IEEE 802.16e-04/81

Project	IEEE 802.16 Broadband Wireless Access Working Group < http://ieee802.org/16 >	
Title	Enhancing MIMO features for OFDMA PHY layer	
Date Submitted	2004-04-25	
Source:	Wen Tong, Peiyong Zhu, Mo-Han Fong, Jianglei Ma, Hang Zhang and Ming Jia Nortel Networks 3500 Carling Avenue Ottawa, ON. K2H 8E9 CANADA	Voice: (613)-763-1315 Fax: (613)-765-7723 wentong@nortelnetworks.com
Re:	Sponsor re-circulation Ballot	
Abstract	Contribution elaborating of the MIMO enhancements for 802.16d OFDMA	
Purpose	Adopt into IEEE 802.16 REVd/D4 - 2004	
Notice	This document has been prepared to assist IEEE 802.16. It is offered as a basis for discussion and is not binding on the contributing individual(s) or organization(s). The material in this document is subject to change in form and content after further study. The contributor(s) reserve(s) the right to add, amend or withdraw material contained herein.	
Release	The contributor grants a free, irrevocable license to the IEEE to incorporate material contained in this contribution, and any modifications thereof, in the creation of an IEEE Standards publication; to copyright in the IEEE's name any IEEE Standards publication even thoug

Figure x1

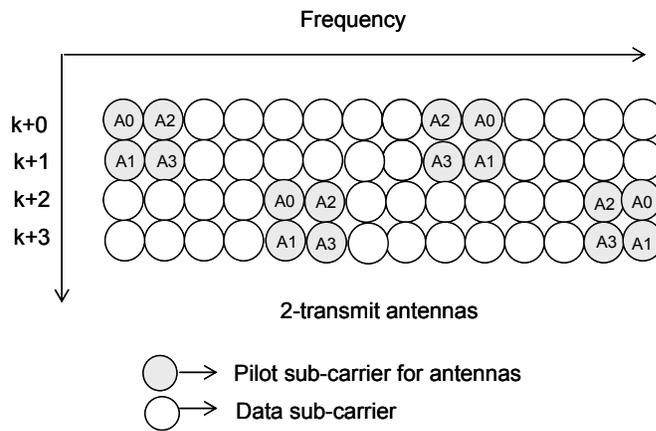
For 2-transmit the PUSC cluster pilot locations are shown in Figure x-1. When 4-transmit antennas are used, the pilots for antenna 2 and 3 pilots are punctured into corresponding data carrier locations as shown in Figure x-1

Figure x-3 UL MIMO collaborative spatial multiplexing tile

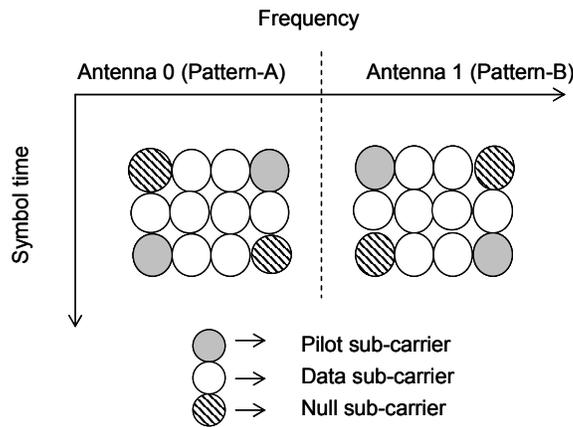
A two transmit MIMO burst in the uplink is defined as MIMO tile and uplink bin, 2-transmit diversity data or 2-transmit spatial multiplexing data can be mapped onto each subcarrier, each MIMO tile is composed of 4-continuous subcarriers and 3-continuous time symbols. It's configuration is illustrated in Figure xxx-1. One subchannel is constructed from 8 uplink MIMO tiles, within each burst, there are 64 data subcarriers and 32 fixed-location pilot subcarrier.

Two single transmit antenna SS's can perform collaborative spatial multiplexing onto the same subcarrier. In this case, the one SS should use the uplink tile with pattern-A, and the other SS should use the uplink tile with pattern-B. Figure x-3 depicts the uplink tile
